# Service Letter No. 72

**SUBJECT:** Glider/Banner Tow Release Handle Installation inspection and Mounting Bracket orientation correction, if required.

**AIRPLANES AFFECTED:** All Maule Models with Glider/Banner Tow Hitch.

Sketch for inspection and of detailed heading correction if necessary:

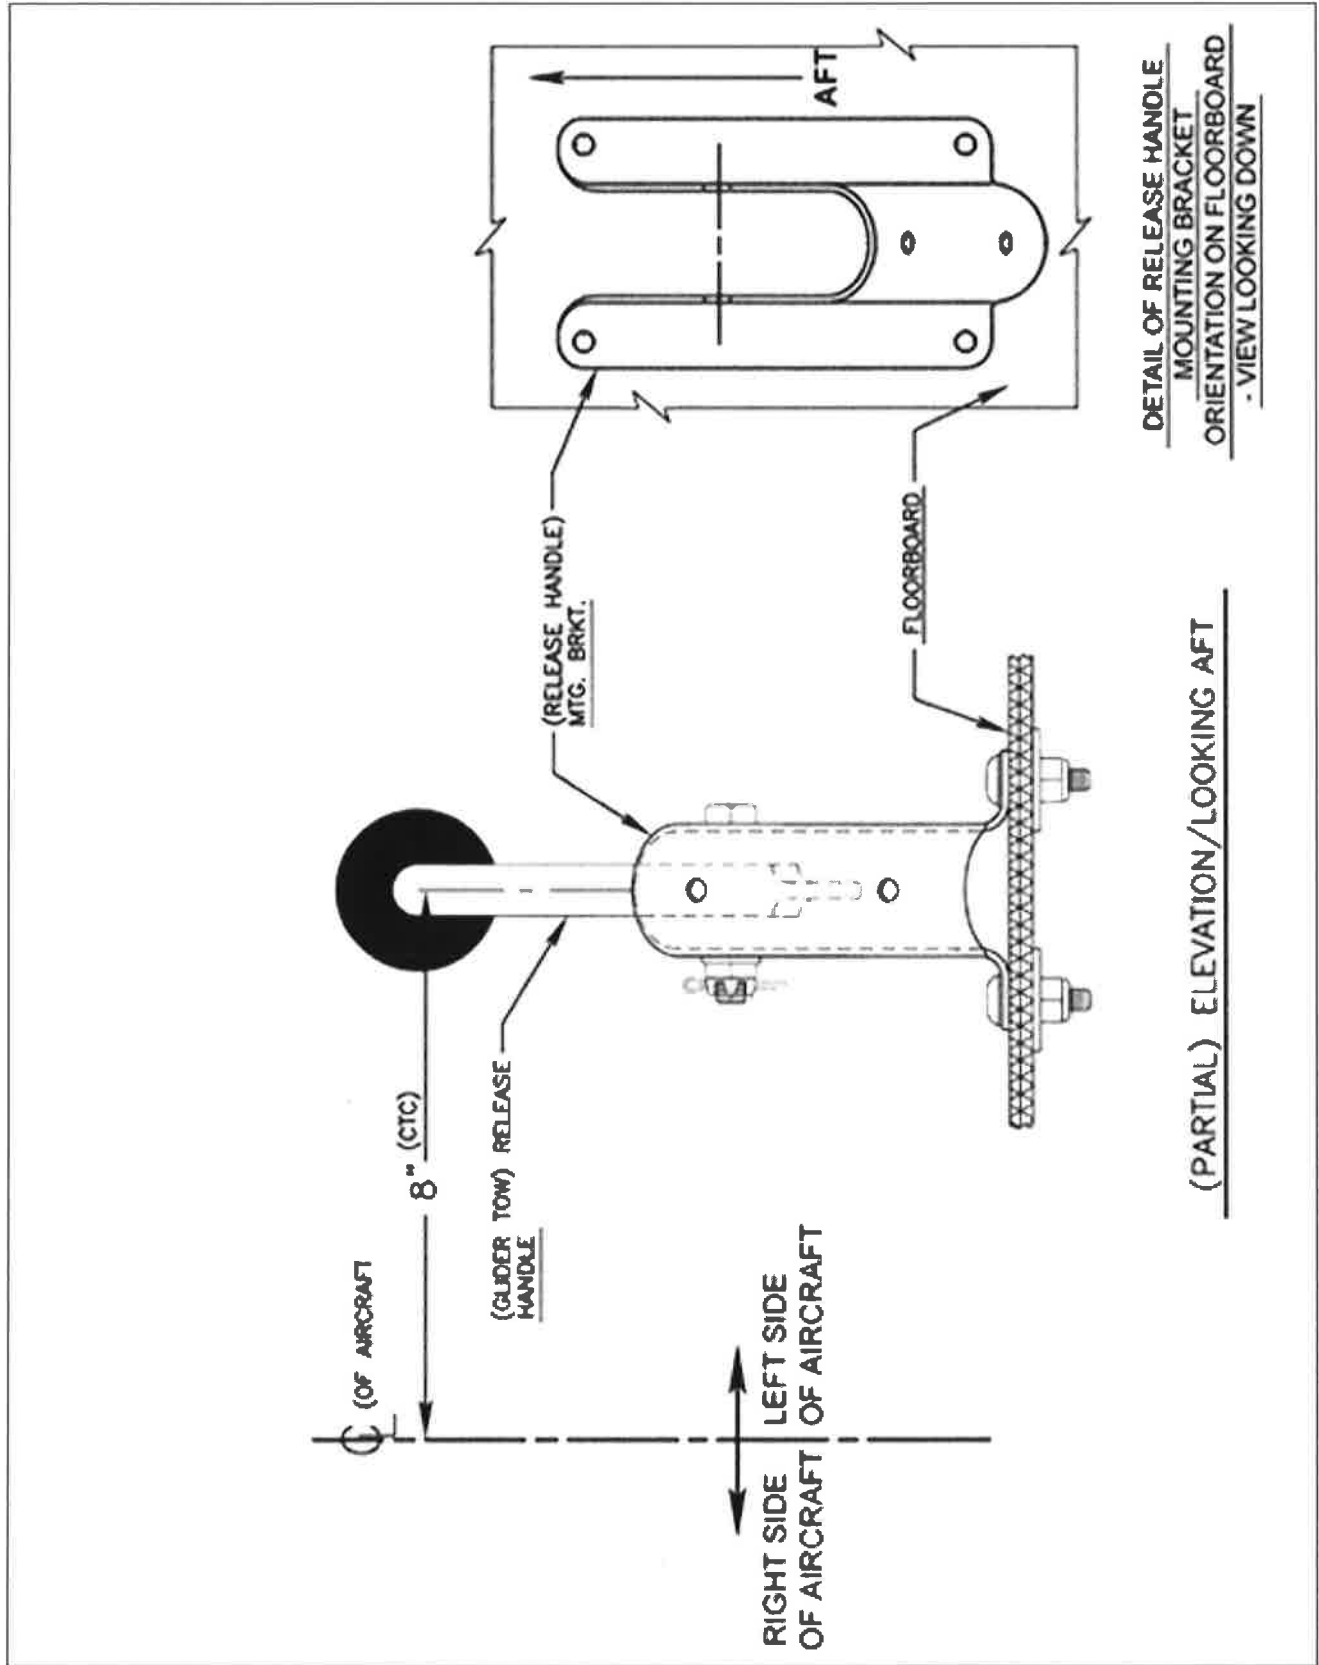
**BACKGROUND:** It has come to our attention that a Glider Tow Release Handle Mounting Bracket was installed in the wrong direction on the airplane floorboard in the field. Upon viewing the drawing showing the Bracket installation, we observed that it was in error and it has been corrected. Bracket is shown in the correct orientation on page 2 of this Service Letter. A long and many time Glider Tow Equipment installer at Maule said the Mounting Bracket had always been correctly placed by him here at the factory.

- 1) Check heading of Mounting Bracket installation using sketch on page 2. Take note that the higher end of the bracket is toward the rear of airplane and that the location of the installation is on the pilot's (left) side.
- 2) If installation is as it should be, no further action is required.
- 3) If Bracket is in the reversed direction, correct installation before further towing flight.
